## Determination 2007/95

### Decorative elements associated with a swimming pool at 3 Skara Brae, Prebbleton

**Figure 1: Plan of the pool and fenced area**

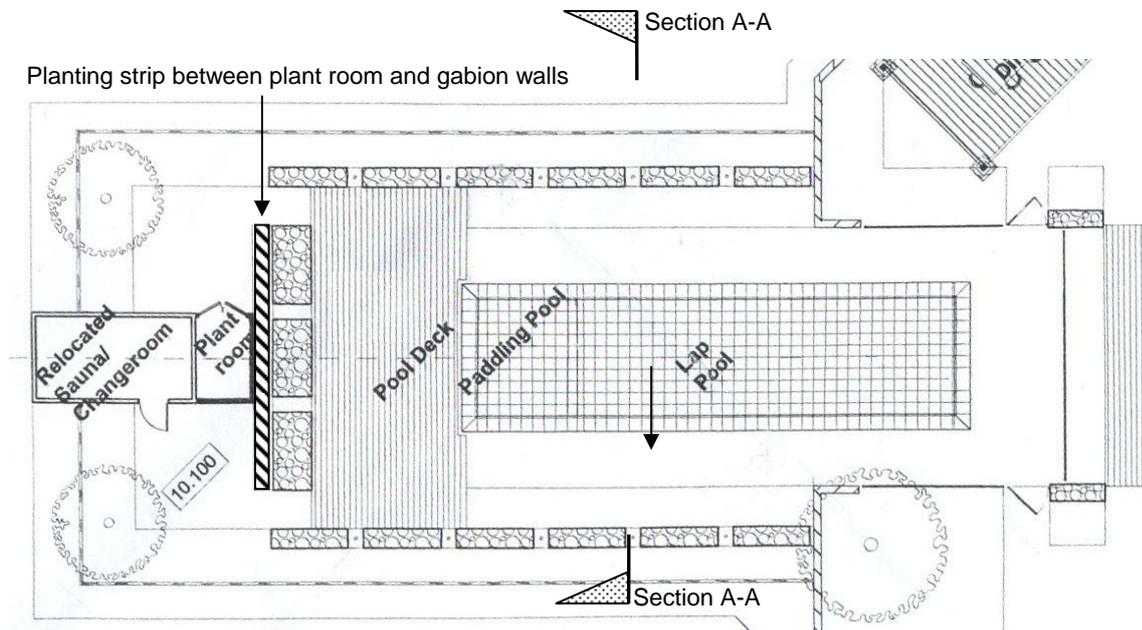
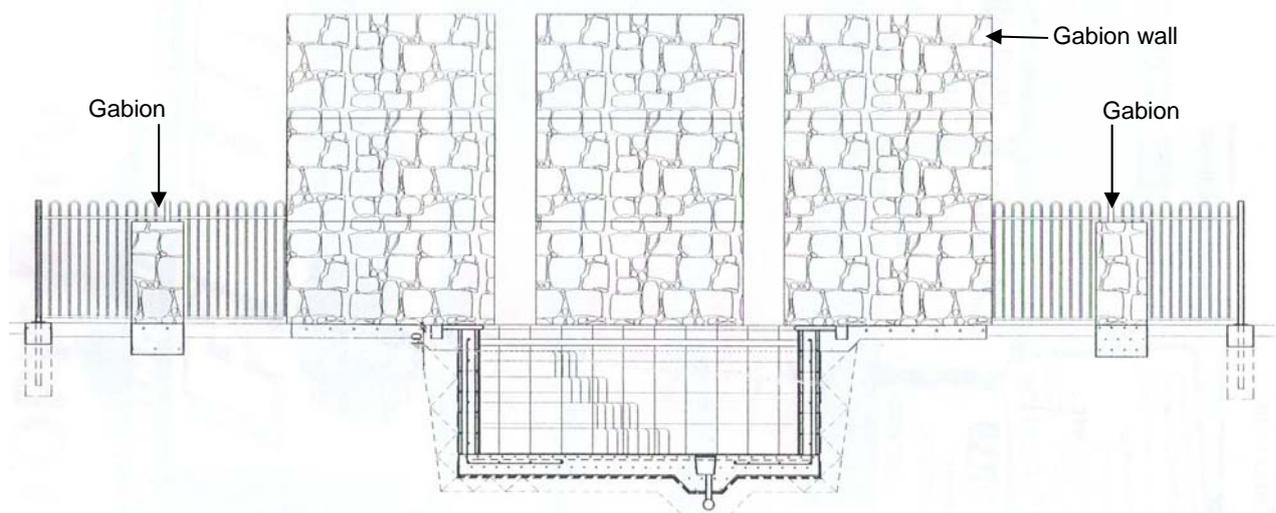
- 1.3 The application arises from the refusal by the territorial authority to issue a building consent for building work involving alterations to a swimming pool which include the installation of certain decorative elements (which the territorial authority referred to as “landscaping features”). There is also some concern about trees close to the fencing. There is no dispute that the fencing itself, including gates, complies with clause F4. Relevant details are shown in Figures 1 and 2 below.

- 1.4 As shown in Figures 1 and 2, the decorative elements inside the area enclosed by fencing (“the fenced area”) consist of river-stone filled gabion baskets 500 mm wide and either 1,000 mm high (“the gabions”) or 2,000 mm high (“the gabion walls”) plus a 6.8 m by 0.5 m planting strip behind the gabion walls.

It appears that the inclusion of the Gabion stone walls within the immediate pool area is an “activity” which cannot be described as being closely connected with the use of the pool i.e. a landscape feature, and therefore cannot be included. Council’s concern is that a young child could “hide” behind these features and be overlooked by the supervising adult/s leaving the pool area. Also of concern are the trees within the immediate pool area for the same reason.

The tree outside the fence may provide an access route into the immediate pool area.

Therefore, an amended pool fence layout for the immediate pool area is now required excluding these items.

- (a) I do not share the territorial authority’s concern about a child hiding behind a gabion basket or a gabion wall (or, for that matter, within the changing shed). On the contrary, I consider that an adult who is in the fenced area of a domestic pool such as this one is likely to be well aware of how many children are also in the area so that a hiding child is most unlikely to be overlooked.

- (b) I consider that there is no significant danger that an adult in the fenced area who was working on the planting strip between the gabion walls and the plant room would not be aware that a child had fallen into the pool. That is not to say that such a danger might not arise in other pools with larger fenced areas and more extensive planting.

- (c) Similarly, I consider that the presence of that small planting strip does not raise the likelihood of a self-closing gate being propped open as contemplates in NZS 8500.

I therefore conclude that despite the presence of the decorative elements, the fenced area can properly be called the immediate pool area.

- a) determine that, despite the presence of decorative elements, the fenced area can properly be called the immediate pool area or the immediate pool surround and that therefore the pool fencing complies with clause F4
- b) reverse the territorial authority's decision to refuse to issue a building consent in respect of the alterations to the pool.
